SERVICE BULLETIN AMATEUR RADIO

SUBJECT SM-230 RTTY CROSS PATTERN ATTENUATION

DATE 08/08/90

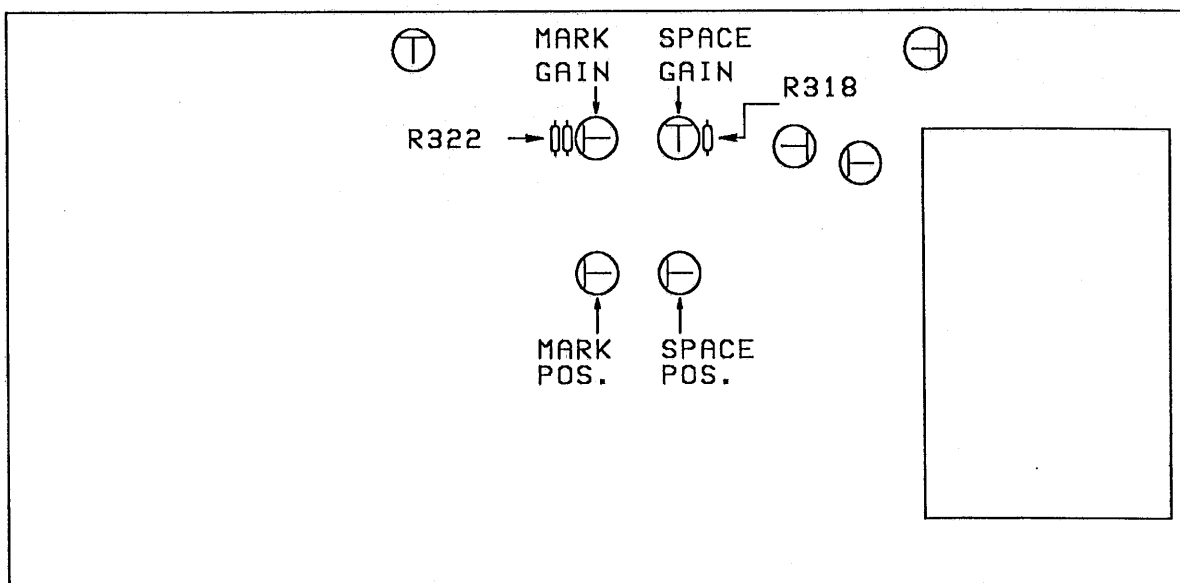
Some users of the SM-230 have reported that the MARK and SPACE gain adjustments do not sufficiently reduce the signals to display them on the CRT. The following modification will correct this condition.

680 OHM 1/8W RESISTOR RD14CB2B681J QTY. 2

1. Disconnect the power cord and control cables.
2. Remove the top cover (6 screws).
3. Locate the Horizontal unit. This board is vertically mounted on the right side of the SM-230.
4. Locate resistors R318 and R322 on the Horizontal unit.
5. Replace R318 and R322 with 680 ohm resistors.
6. Assemble the SM-230.
7. Adjust the MARK and SPACE gain adjustments as necessary to obtain the correct cross pattern.
